Technical Committee on Sprinkler System Installation Criteria

First Draft Meeting
August 9-12, 2016

AGENDA

Figure 8.6.5.1.2(c) Obstructions Against Walls (SSU/SSP).

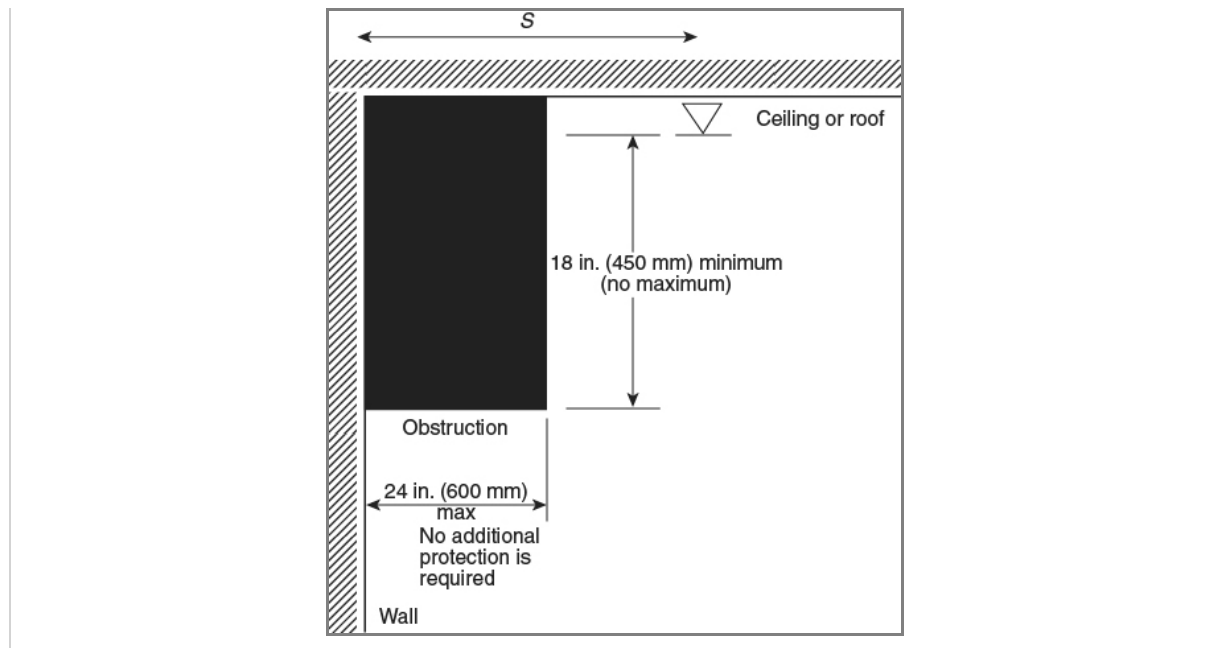
In Figure 8.6.5.1.2(c) revise the vertical dimension for the sprinkler deflector to the bottom of the obstruction distance as follows:

Also, revise the horizontal dimension for the sprinkler to the wall at the back of the obstruction distance as follows:

Additionally, in its current state Figure 8.6.5.1.2(c) is inconsistent with the similar new Figure 8.9.5.1.4(c) and Figure 8.10.7.1.4(c), which properly indicate the " $\frac{1}{2} S$ " and the "No maximum" dimensions.

S **½ S**

Figure 8.6.5.2.1.3(a) Minimum Distance from an Obstruction in the Vertical Orientation (SSU/SSP). Delete this figure and replace with correct figure (see uploaded document)

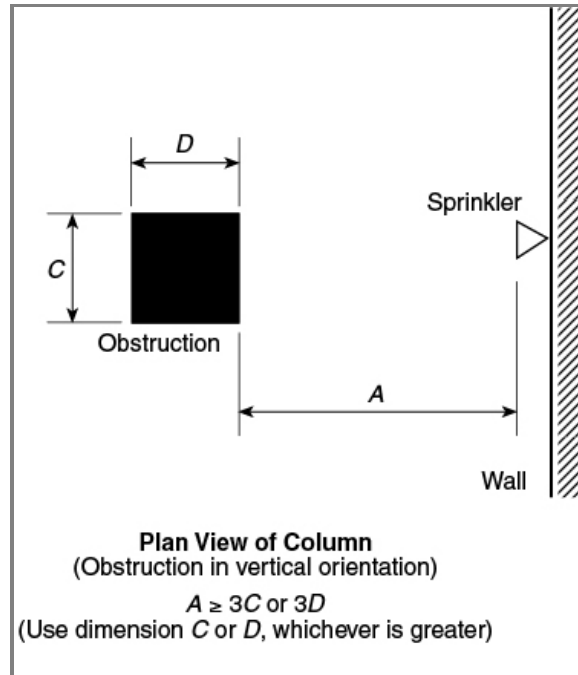
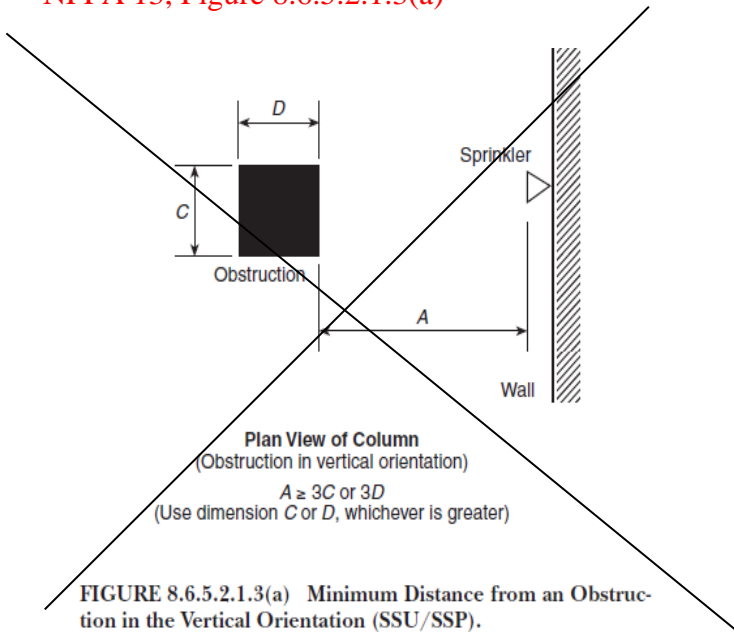
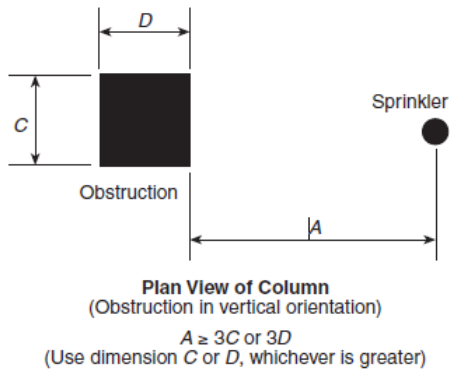
Problem: Figure 8.6.3.2.1.3(a) is the 3 times rule for SSU/SSP sprinklers but figure shows sidewall sprinkler

Proposal: Submit correct figure

Figure 8.8.5.1.2(c) Obstructions Against Walls (Extended Coverage Upright and Pendent Spray Sprinklers).

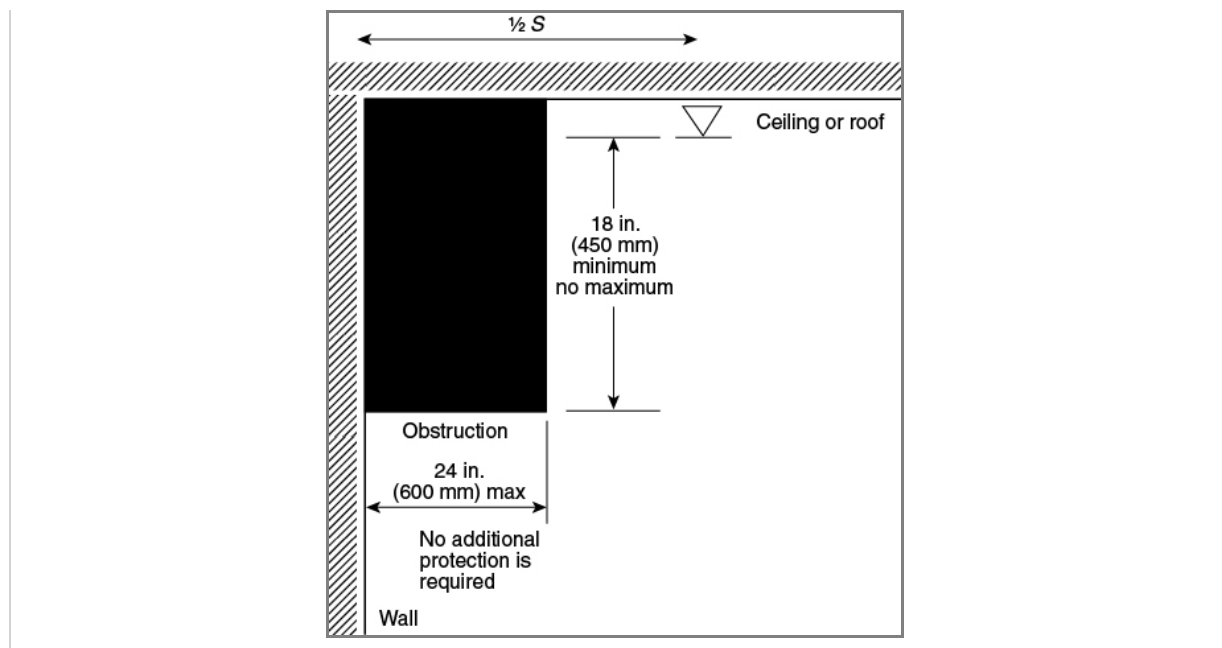
In Figure 8.8.5.1.2(c) revise the vertical dimension for the sprinkler deflector to the bottom of the obstruction distance as follows:

Additionally, in its current state Figure 8.8.5.1.2(c) is inconsistent with the similar new Figure 8.9.5.1.4(c) and Figure 8.10.7.1.4(c), which properly indicate the "No maximum" dimensions.

18 in. (450 mm) minimum (no maximum) **No maximum**

Figure 8.8.5.2.1.3(a) Minimum Distance from an Obstruction in the Vertical Orientation (Extended Coverage Upright and Pendent Spray Sprinkler).

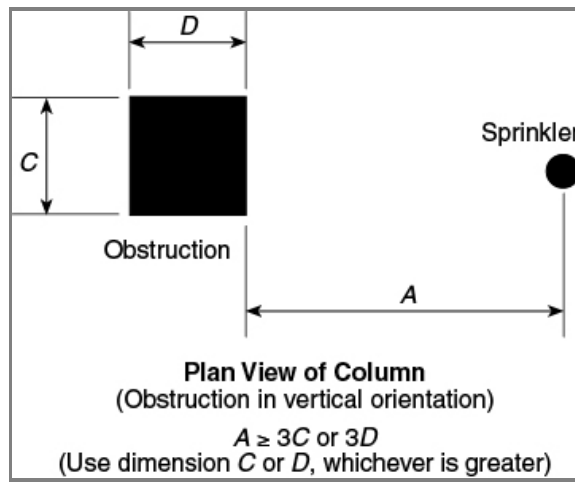
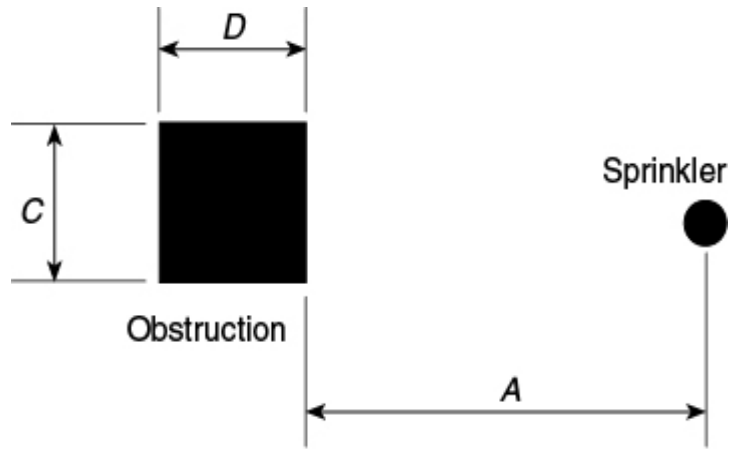
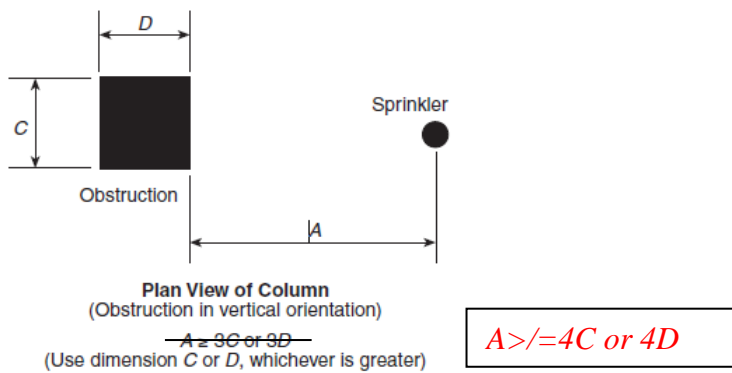
Figure 8.8.5.2.1.3(a) needs to be edited as per attached.

Problem: Figure is 4 times rule for EC but figure states 3x not 4x

Figure 8.10.6.1.2(c) Obstructions Against Wall (Measurements for Residential Upright and Pendent Spray Sprinklers).

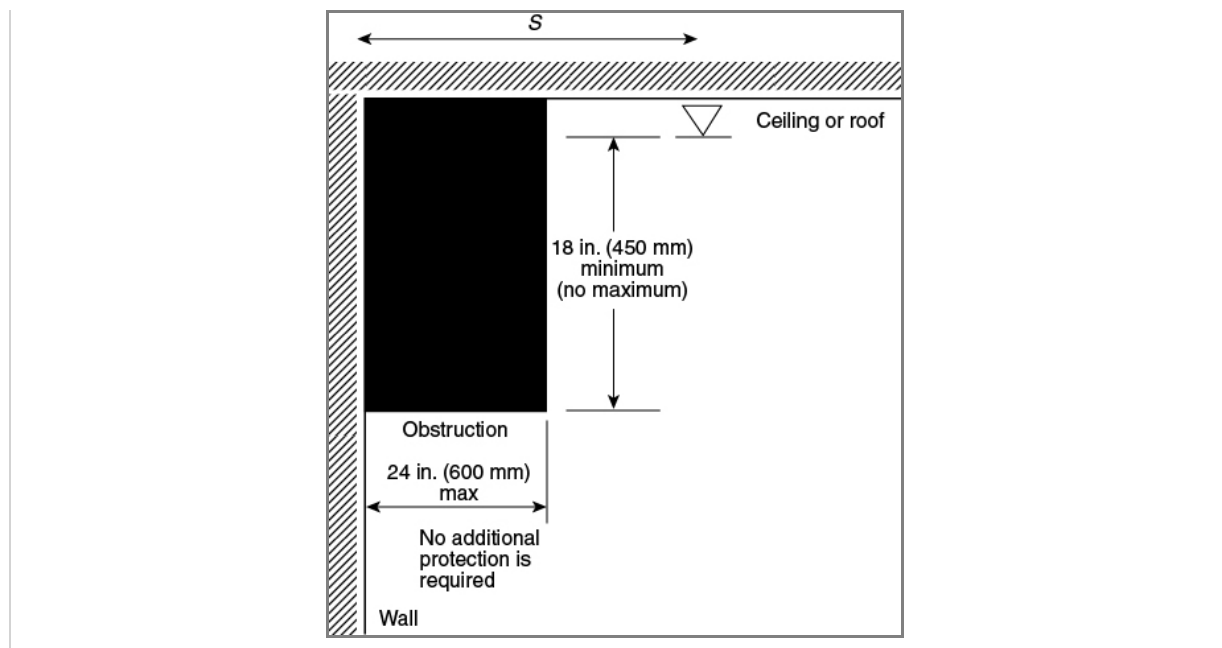
_____ In Figure 8.10.6.1.2(c) revise the vertical dimension for the sprinkler deflector to the bottom of the obstruction distance as follows:

_____ Additionally revise the horizontal dimension for the sprinkler to the wall at the back of the obstruction distance as follows:

Additionally, in its current state Figure 8.10.6.1.2(c) is inconsistent with the similar new Figure 8.9.5.1.4(c) and Figure 8.10.7.1.4(c), which properly indicate the " $\frac{1}{2}$ S" and the "No maximum" dimensions.

_____ 18 in. (450 mm) minimum (no maximum) _ **No maximum**

Proposed Figure 8.10.7.2.2(b)
[New]

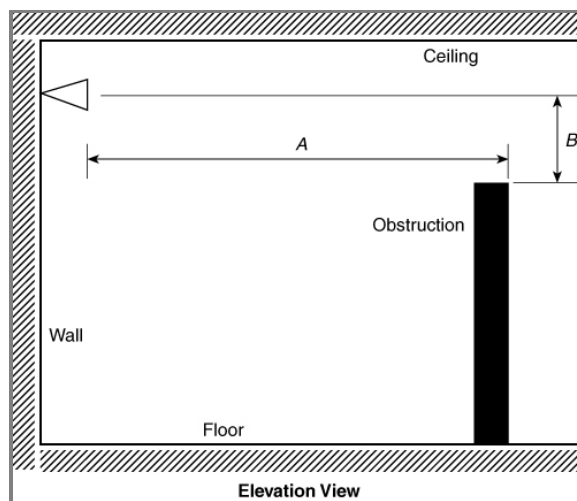
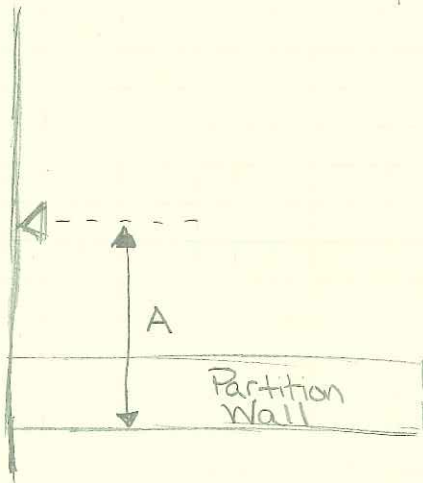
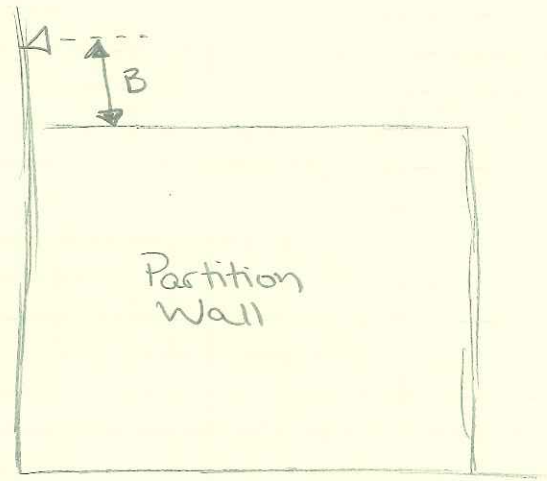
Currently, Figure 8.10.7.2.2 shows the partition parallel to the wall the sidewall sprinkler is installed upon. A partition wall that is below the level of the sidewall sprinkler could be parallel or perpendicular to the wall where the sprinkler is located. The clearance distances should still be acceptable. The new figure demonstrates where measurements apply for a wall perpendicular to the wall where the sprinkler is located. A statement has also been added to the annex for clarity.

FIGURE 8.6.4.1.3.3 Horizontal Clearance for Sprinkler at Peak of Pitched Roof.

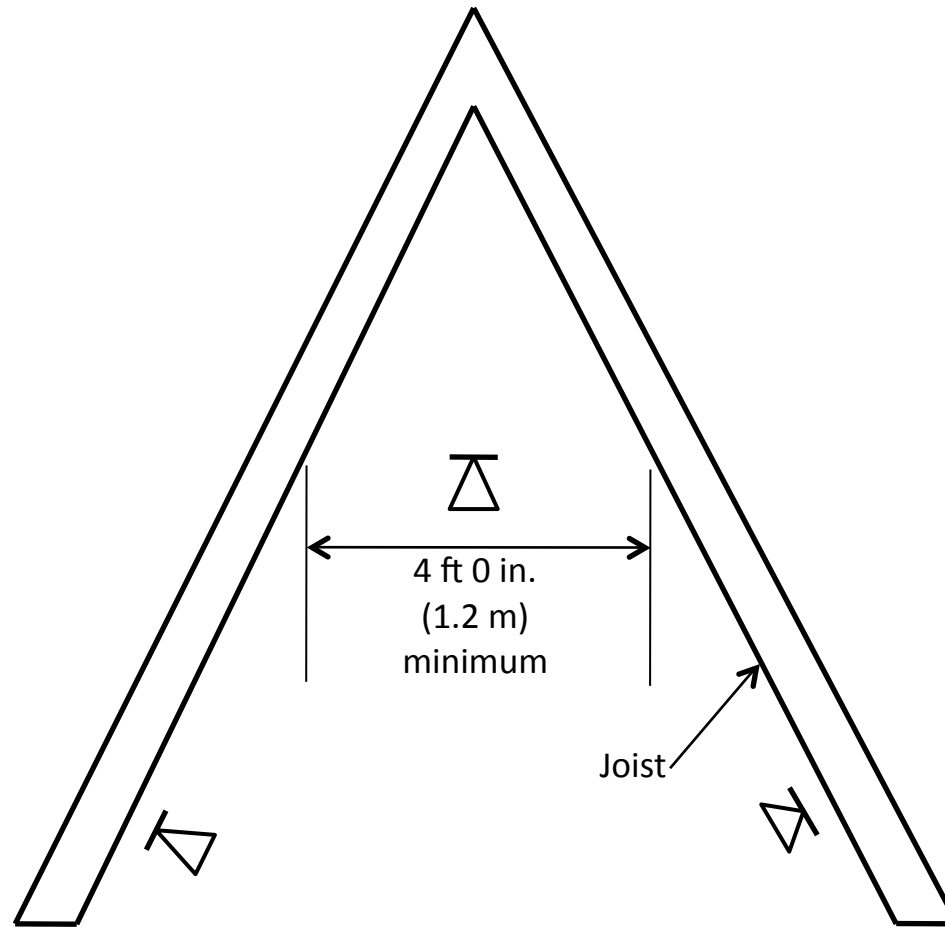
The Figure 8.6.4.1.3.3 should be modified to show a slope greater than 18 in 12. The current figure shows a 12 in 12 slope and does not reflect steeply pitched. The effects of cold soldering for sprinklers should not be considered when proper sprinkler spacing is provided along the slope of the ceiling.

Figure A.8.17.5.2.2(a) Acceptable Piping Arrangement for Combined Sprinkler/Standpipe System.
[14:Figure A.6.3.5(a)]

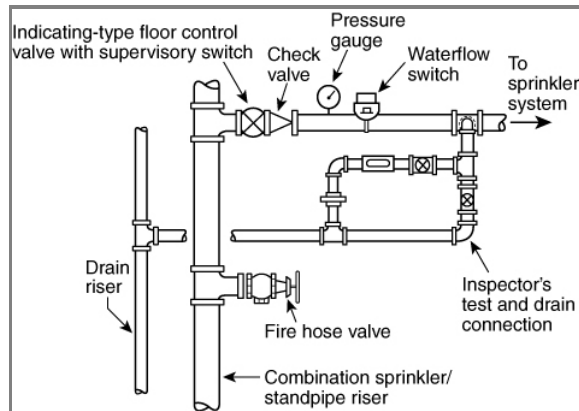
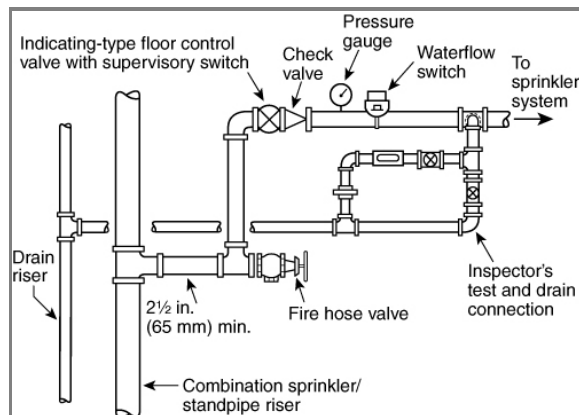
Revise both FIGURE A.8.17.5.2.2(a) and FIGURE A.8.17.5.2.2(b) to show an additional pressure gauge between the floor control valve and the check valve to coordinate with PI for 7.1.12 and A7.1.1.2.
